From: [REDACTED]
Sent: 2025-12-19 星期五 11:58:33
To: [REDACTED]
Subject: Re: Submission of Further Information for Application No. A/YL-PH/1087
Attachment: A_YL-PH_1087 排水建議.pdf

申請地點：新界元朗八鄉橫台山丈量約份第111約地段編號第2808(部份) ，2811
餘段(部份)，2812(部份)，2813(部份)，2814(部份)，2815(部份)
規劃編號：A/YL-PH/1087

提議渠務報告 (Proposed)

簡介 A_YL-PH_1087 回復 20251015 Comment

b4-1

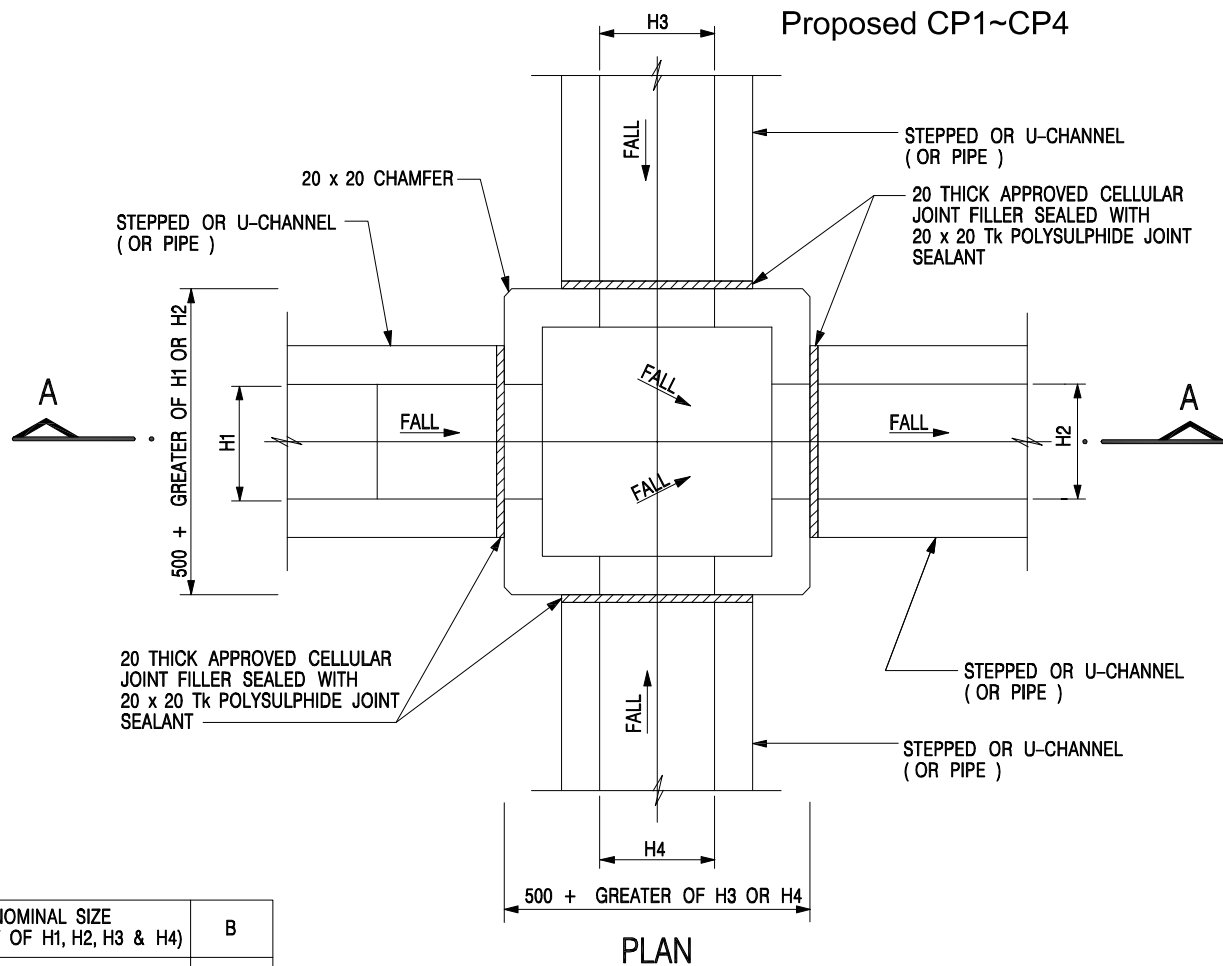
(d) Please show the equation and coefficient for calculation of Q(m discharge of open channel) in the submission.	已修改 在b3-1 中示
(e) Please confirm whether the 400UC after the proposed CP6 is proposed under this application.	已修改 在b2-1 中示

(f) Please show the catchment of the above 400UC and take into account of the relevant surface runoff for the design calculation.	已修改 在b2-1, b3-1 中示
(g) Please show the catchment of the existing 600UC and take into account of the relevant surface runoff for the design calculation.	已修改 在b1-1 & b3-1 中示

(h) 400UC is proposed for the development site. However, the calculation is for 300UC. Please check and clarify.	已修改 在b2-1 中示
(i) Please show runoff coefficients in the submission.	在b3-1 中示
